**RE: LU-22-61 – Response to TAC Comments
77 Meredith Way – Randi & Jeff Collins – Tax Map 162 Lot 16
TFM Project #47442-00**

On behalf of our clients, Randi & Jeff Collins, TFMoran, Inc. (TFM) respectfully submits the following letter in response to the comments made by the City of Portsmouth Technical Advisory Committee (TAC), via emails dated July 1, 2022 & August 1, 2022. The following materials are included in this revised submission:

PROPOSED 2 LOT SUBDIVISION

77 MEREDITH WAY
PORTSMOUTH, NEW HAMPSHIRE

TAX MAP 162 LOT 16
GRADING & DRAINAGE PLAN
PROPOSED 2 LOT SUBDIVISION
77 MEREDITH WAY
OWNED BY
RANDI & JEFF COLLINS
PREPARED FOR
RANDI & JEFF COLLINS
1"=20' (11"X17")
SCALE: 1"=10' (22"X34') **JULY 1, 2022**

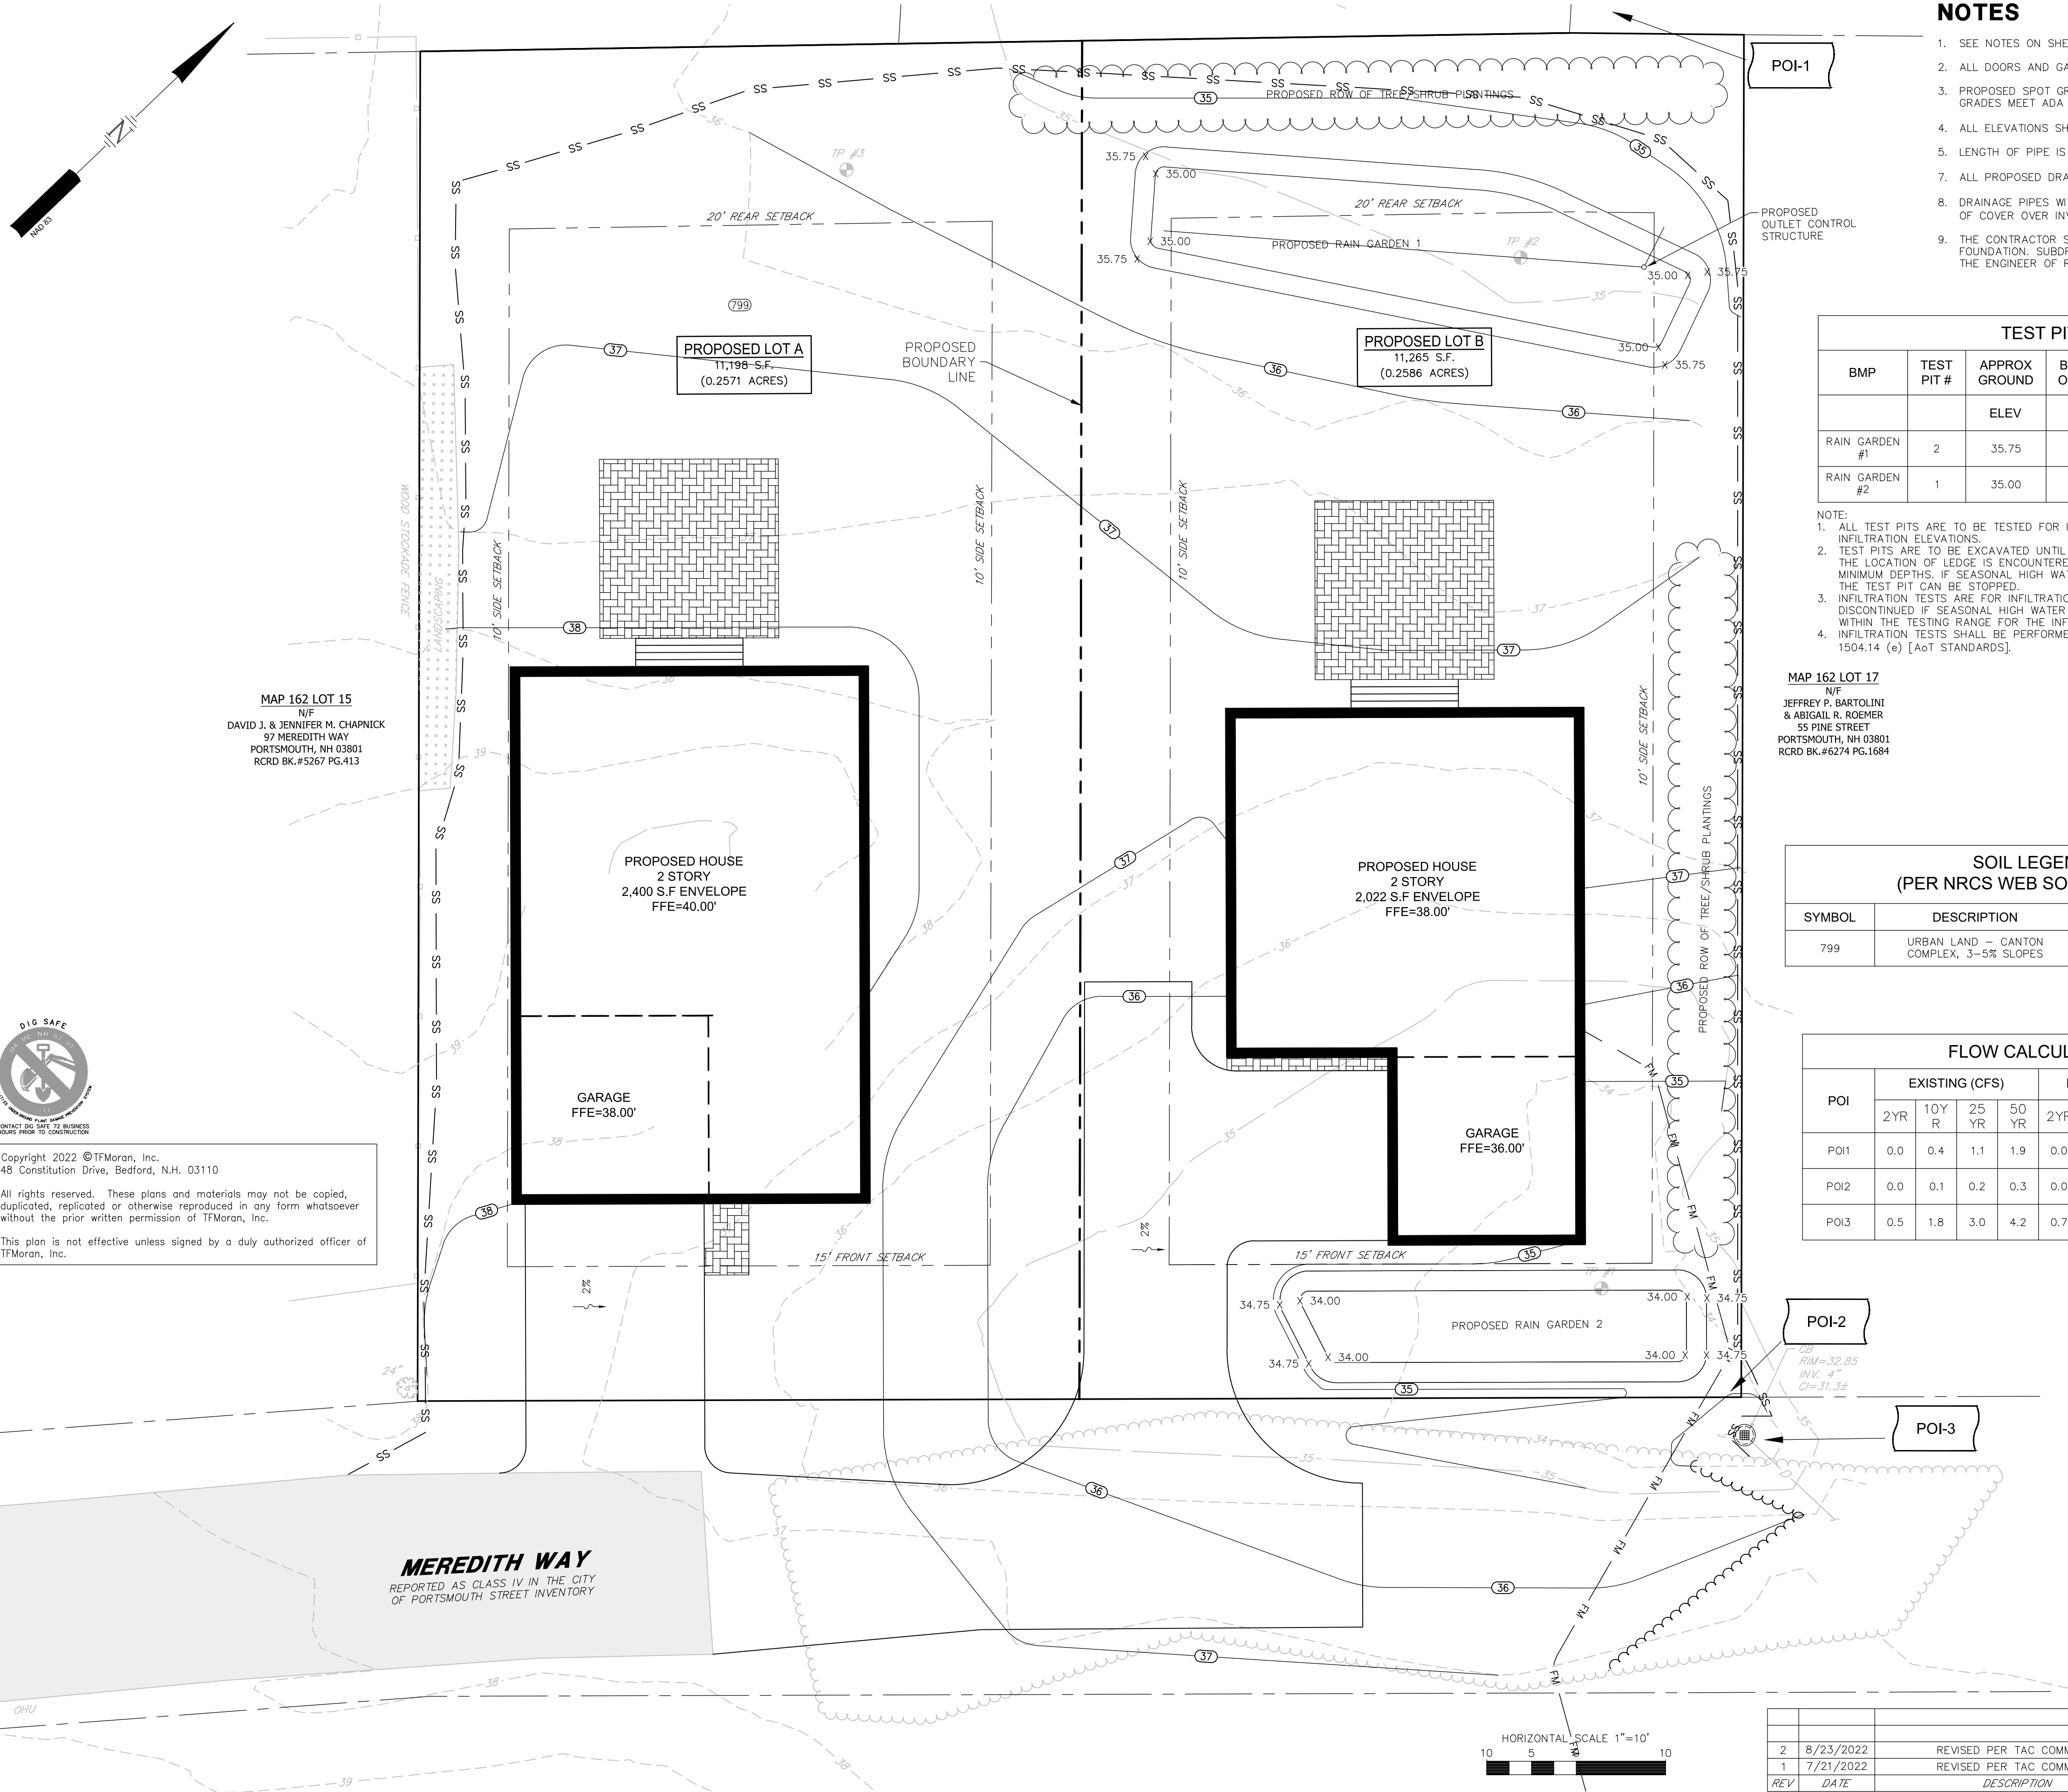
4. Design of rain garden is incomplete. Test pits in location of rain garden results and drainage calculations required.

5. Have test pits been completed? If so, what were the results?

6. Please show drainage calculations.

Updated, test pit info and drainage calculations are shown on sheet C-04 and test pit report provided.

Yes, and test pit info is shown on sheet C-04 and test pit report provided.

Updated, drainage calculations are shown on sheet C-04.

ROAD PLAN PROFILE
PROPOSED 2 LOT SUBDIVISION
77 MEREDITH WAY

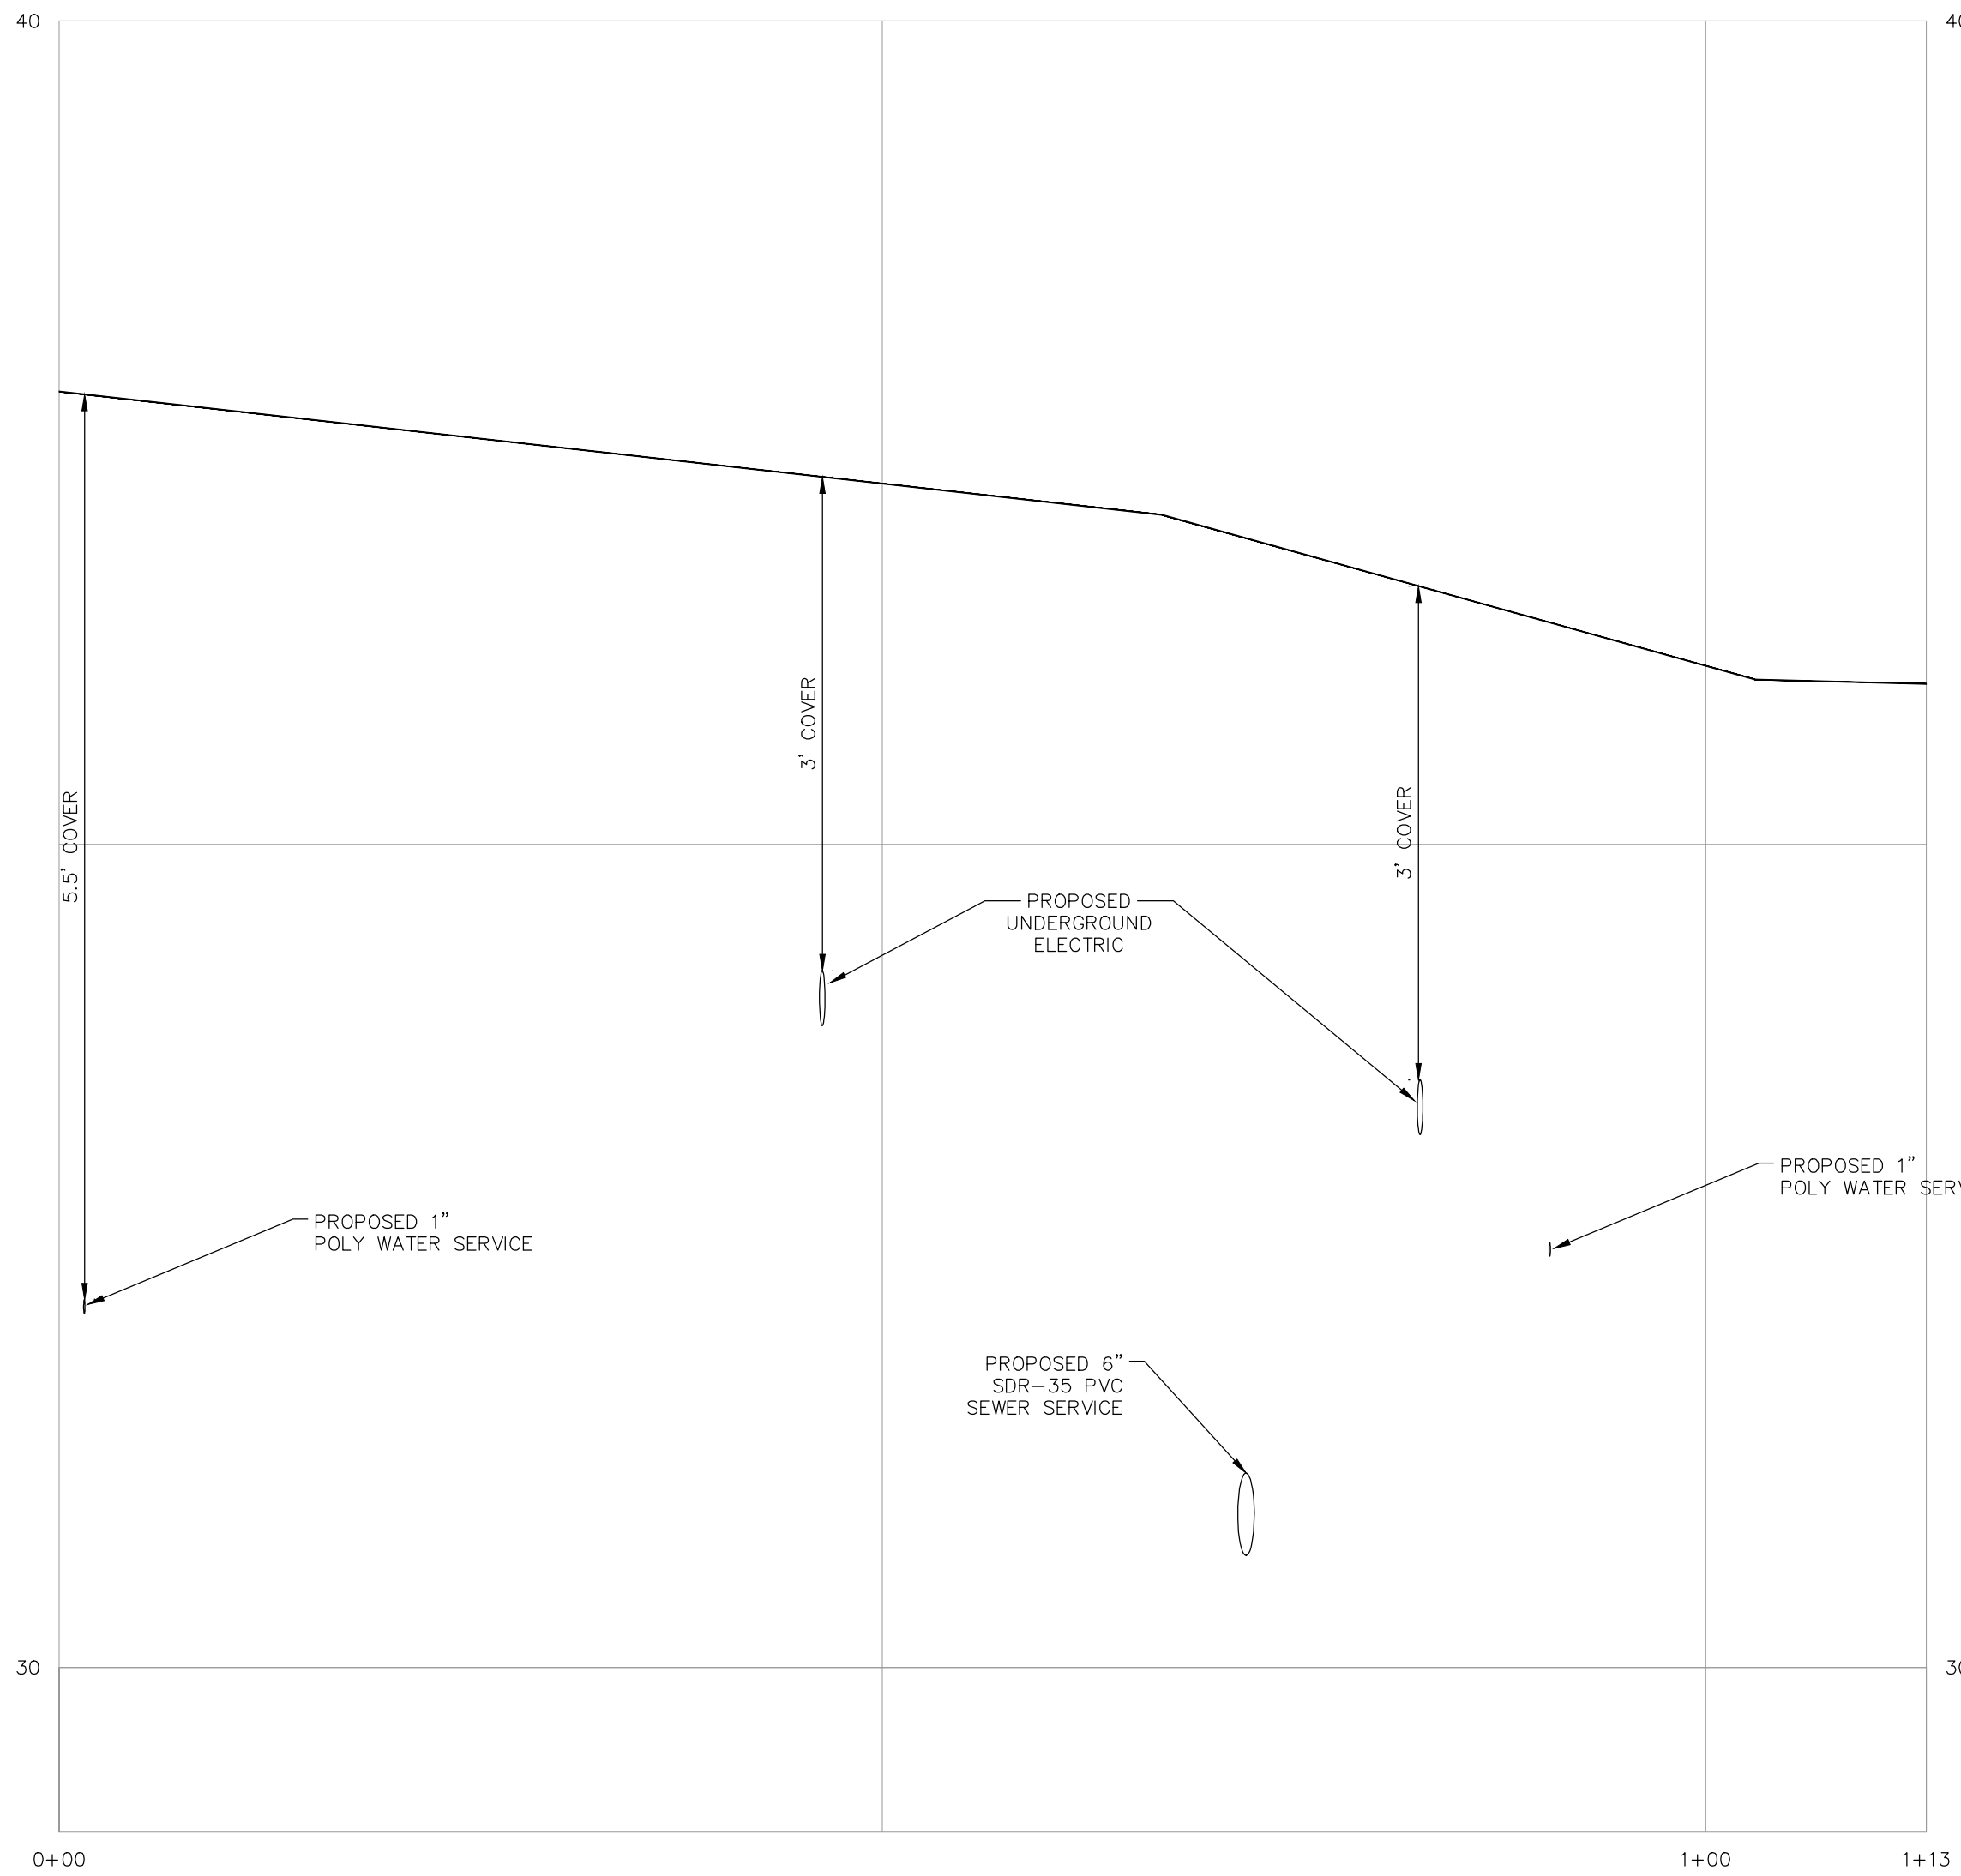
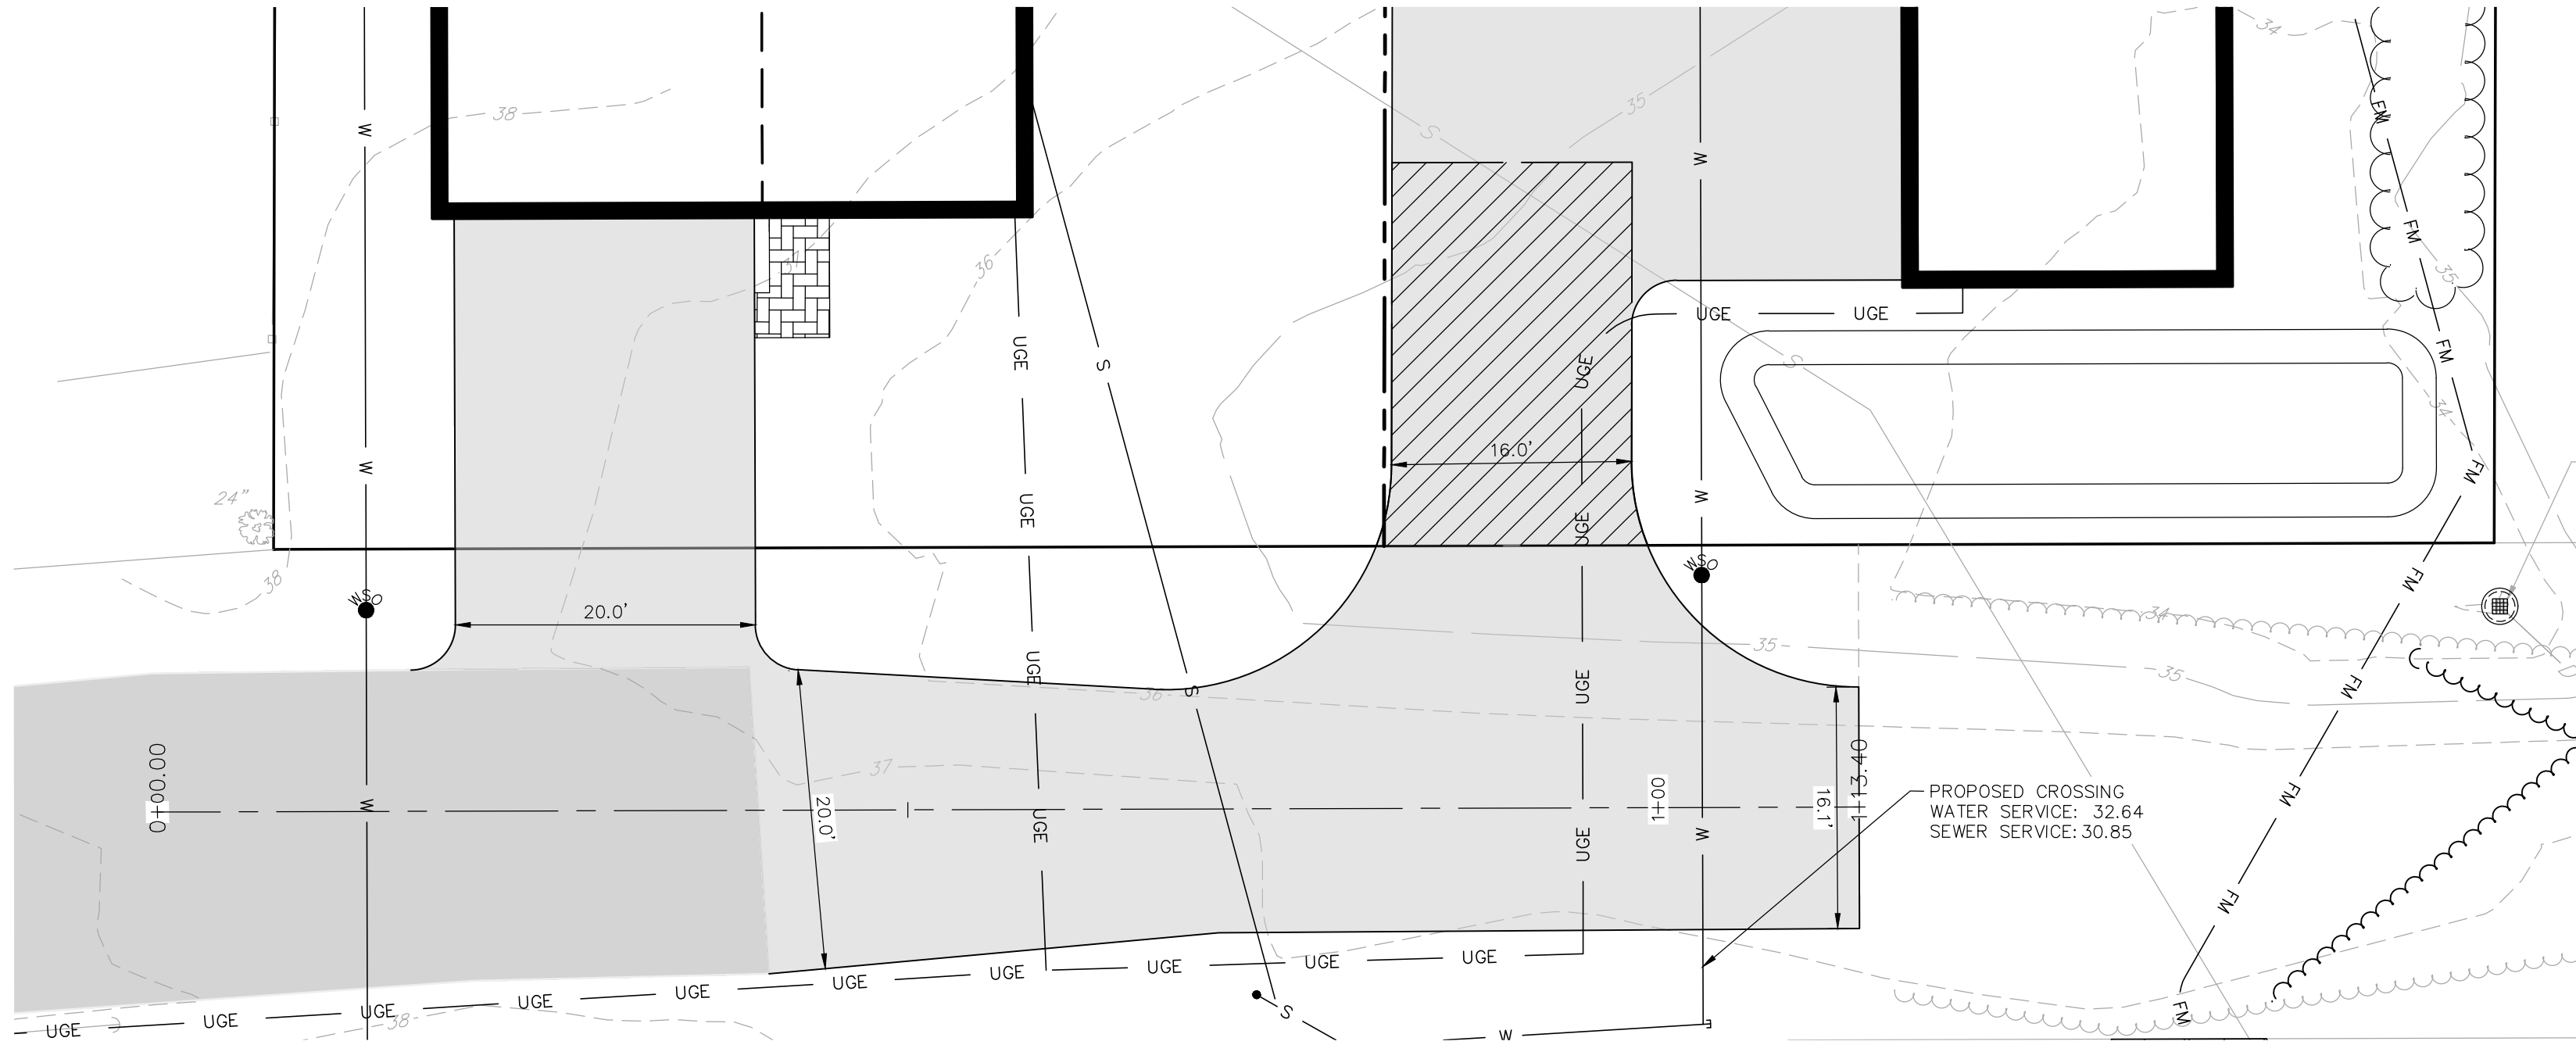
1. Extend roadway 5’ past last driveway.

2. Taper road extension to the 16’ width over 30’.

3. 1.5” water line will need to be extended. 1” water services to both houses.

1. Roadway extension and driveway area for turnaround easement must be built to City standard. Please provide detail for DPW review.

Revised, roadway now 15’ past driveway to accommodate 15’ radius and comply with ZBA approval. See Sheet C-06.

Revised, see sheet C-06.

Revised, see sheet C-06.

Addressed, see sheet C-06 for Road Profile Plan and sheet C-07 for details.
